PLANNING BOARD MEETING AGENDA

July 29, 2026 at 7:30 PM

To: Village of Wesley Hills Planning Board

Re: Friedman – 12A Martha Road Special Permit and Site Plan
SBL# 41.14-1-62; R-50 Zoning District

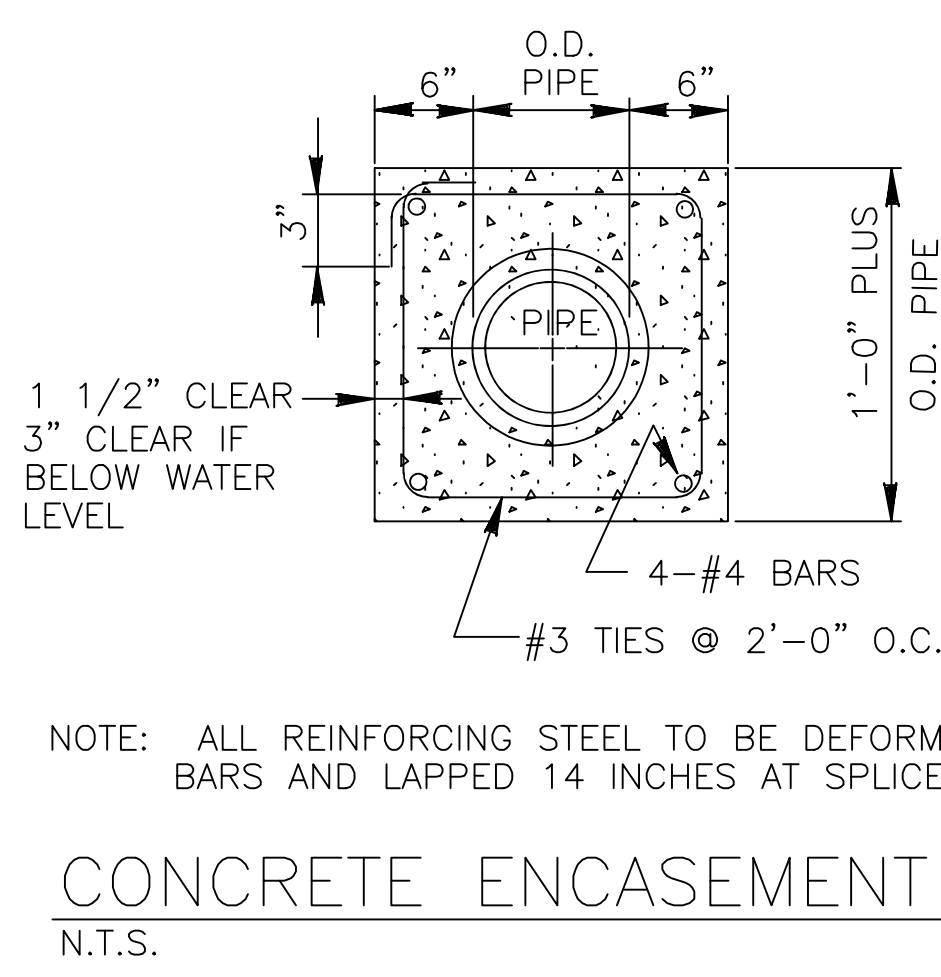
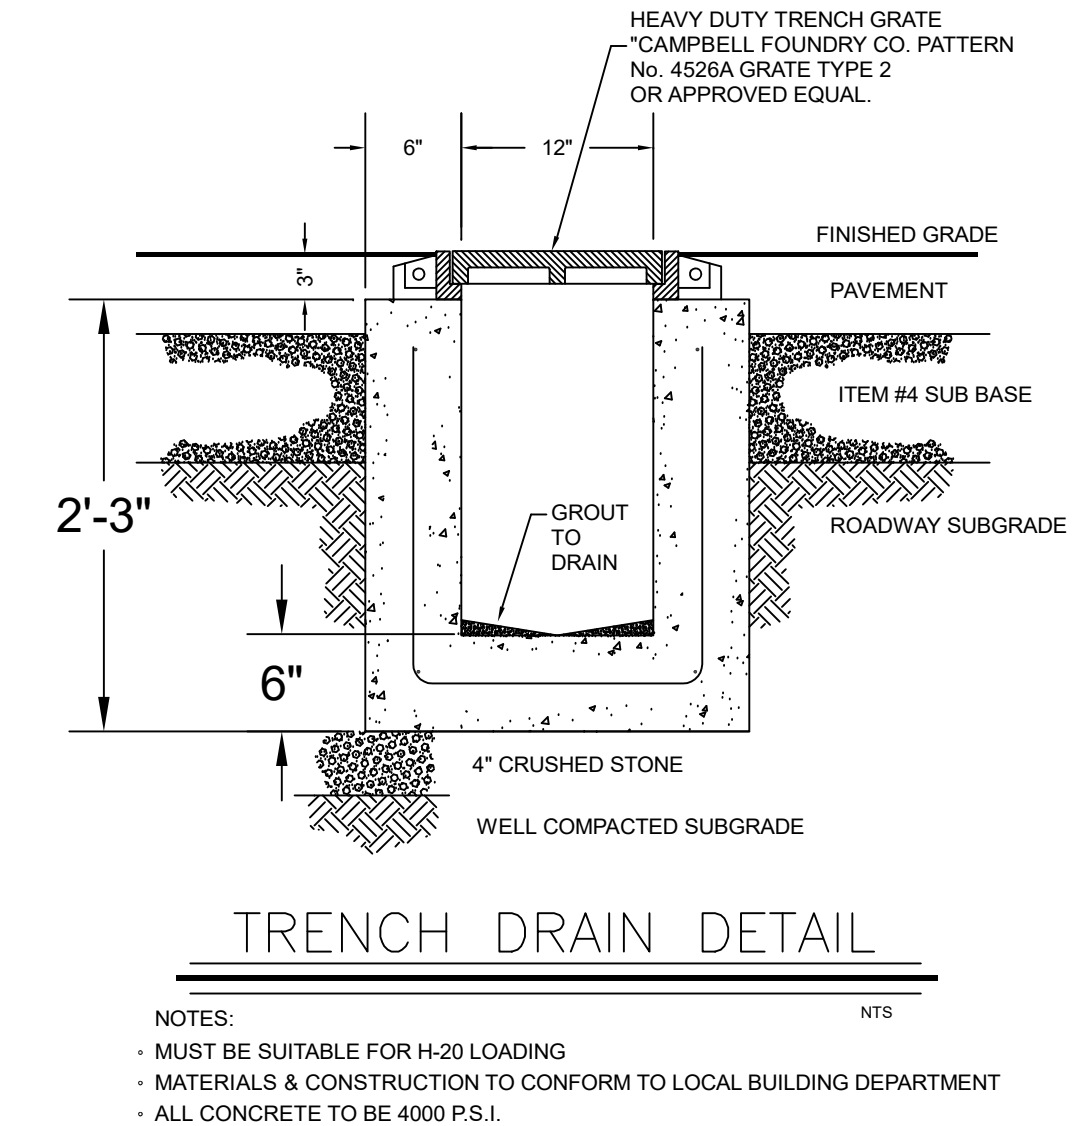
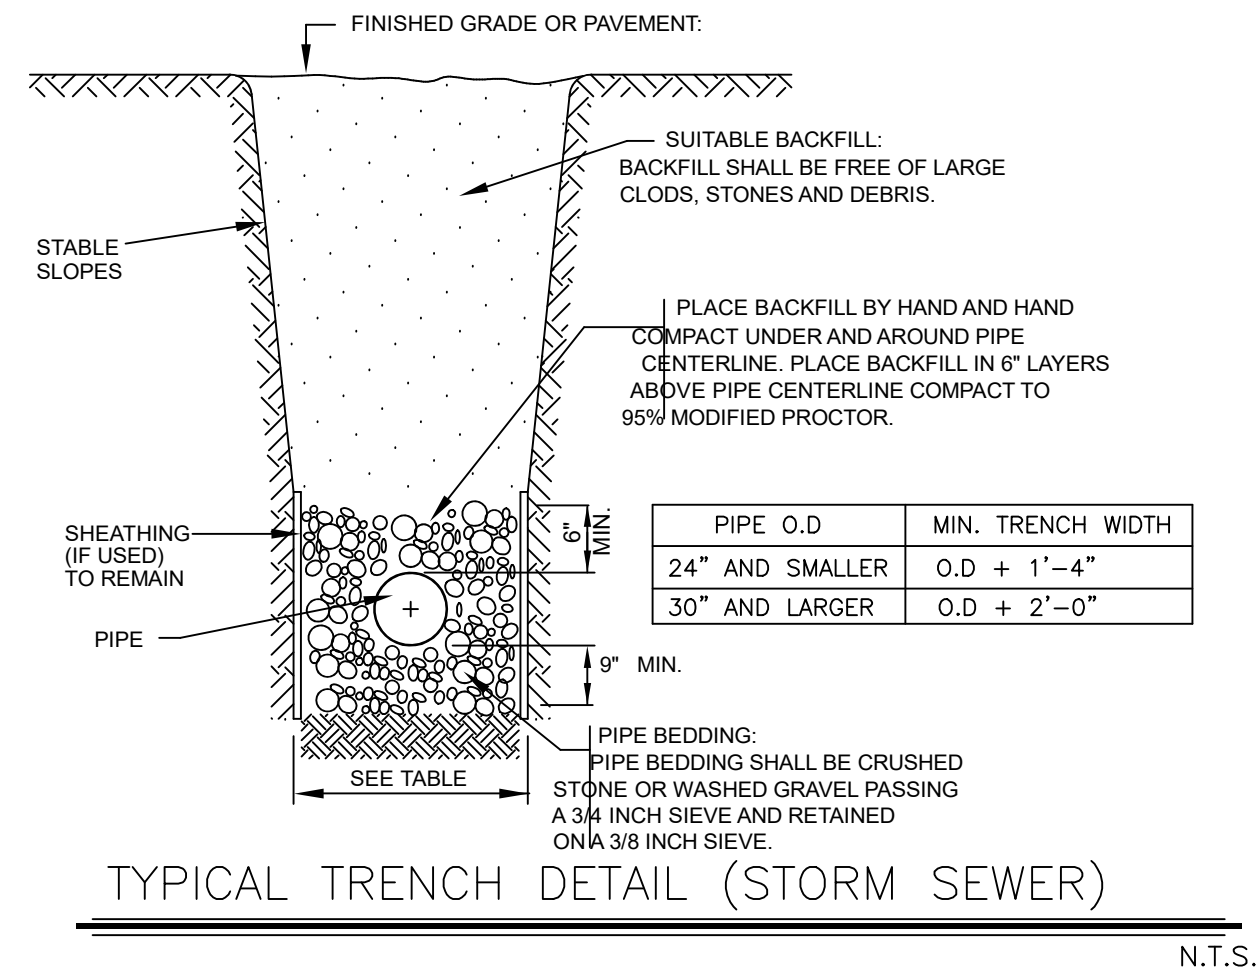
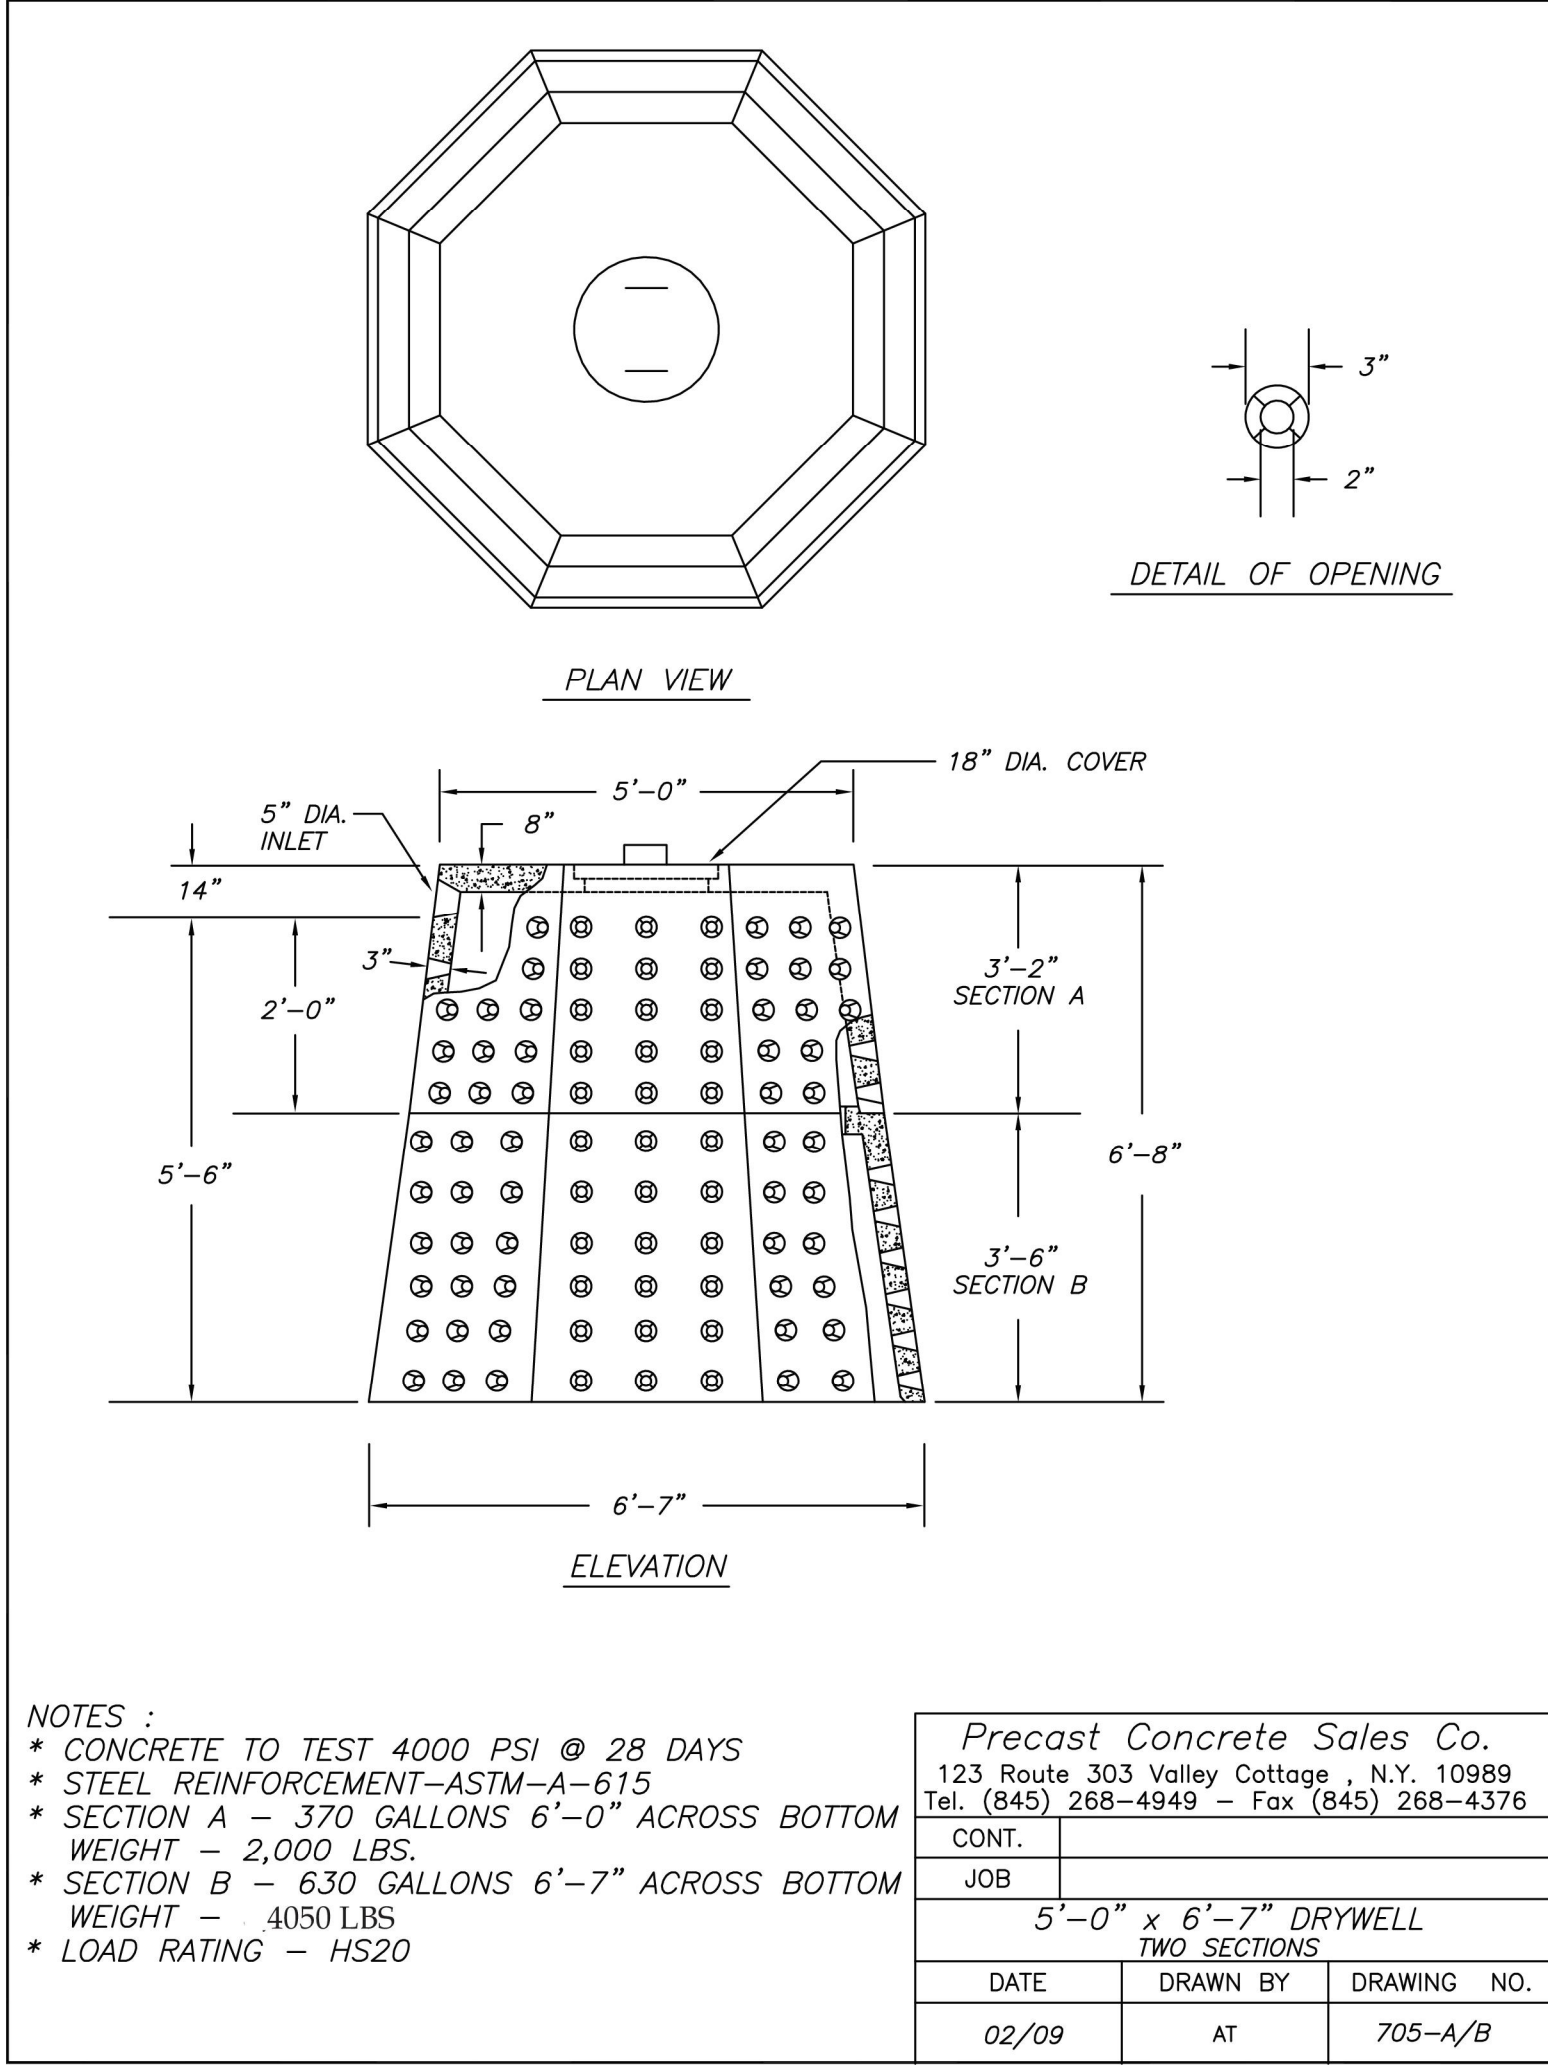
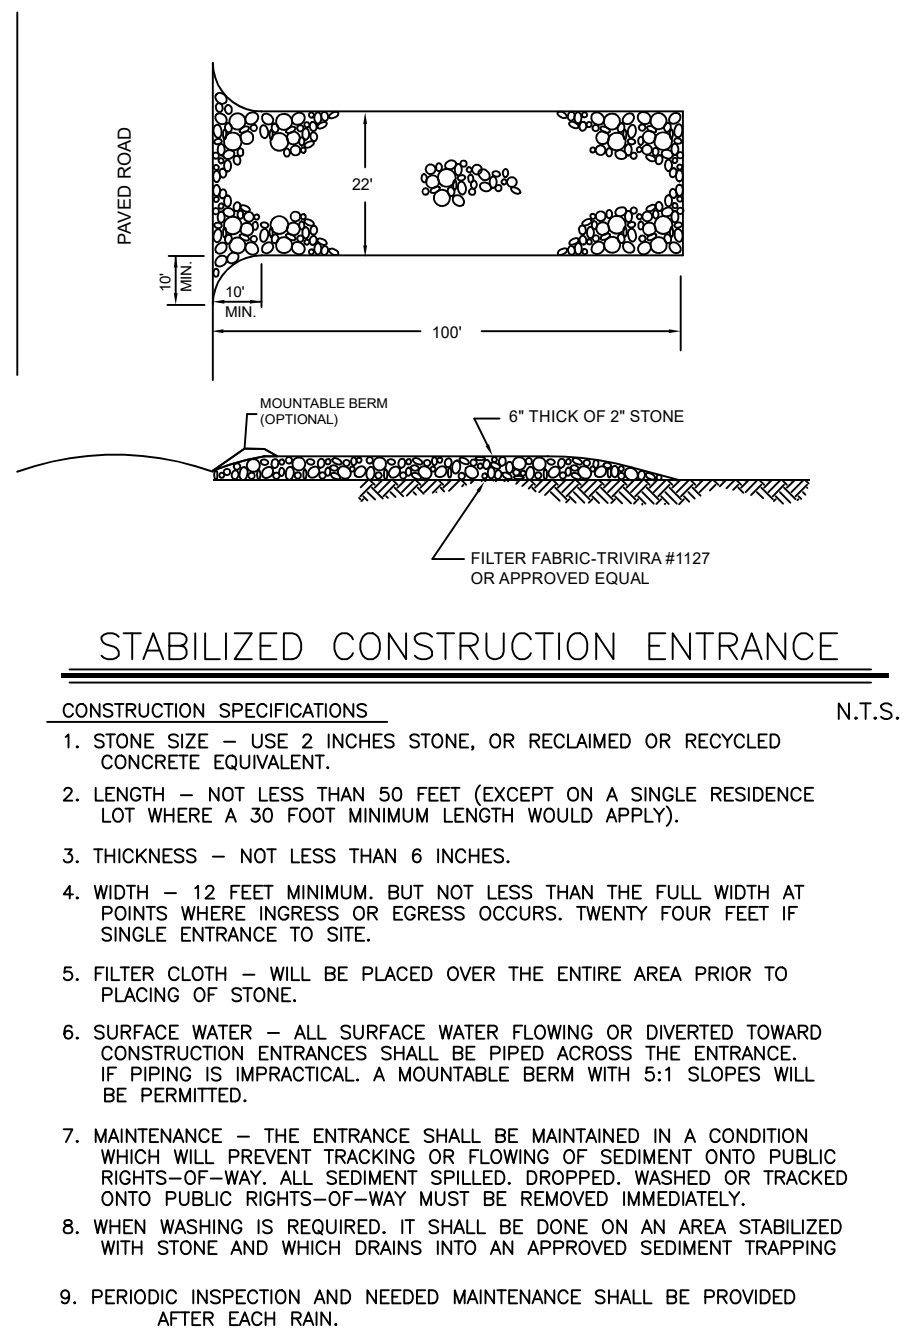
1. Portion of existing pavement is proposed to be removed, soil restoration detail remains to be provided.
2. It is not clear what feature/material is proposed on the west side of the roundabout. Proposed materials remain to be clarified, and labels remain to be provided.

3. It appears as "Pervious Stepping Stones" are no longer proposed near entrance to the house. This remains to be clarified and revised accordingly.
4. For proposed pool please show 4-foot minimum high fencing and self-closing and positive self-latching lockable gate, coping elevation, and spot elevations around the pool to demonstrate stormwater runoff directed away from the pool.

5. Elevations of all corners of proposed house and accessory buildings and structures remain to be provided.
6. Tree protection detail remains to be provided. Please identify trees to be protected on the site plan.

7. Revised drainage calculations show four drywells to be installed for this project. Additional two drywells are now proposed near tennis court; stormwater runoff from the tennis court will be directed into the drainage system.

8. An additional fifth drywell is shown on the west side of the proposed roundabout with no connections. Please clarify what areas will be collected into this drywell. We note that the drainage calculations provided by the Applicant demonstrate that four drywells will satisfy Village requirements for drainage design. Our office has no objections to the installation of the additional drywell on site.

9. Please note, percolation testing will be required for the additional drywells.
10. Per the ZBA condition #2 the Applicant is required to install a berm along the walking path near the tennis court. This berm remains to be shown on the plan.

12. Four ten-foot-high light poles are shown north of the proposed residence. The Applicant shall provide lighting details and demonstrate compliance with §230-54.
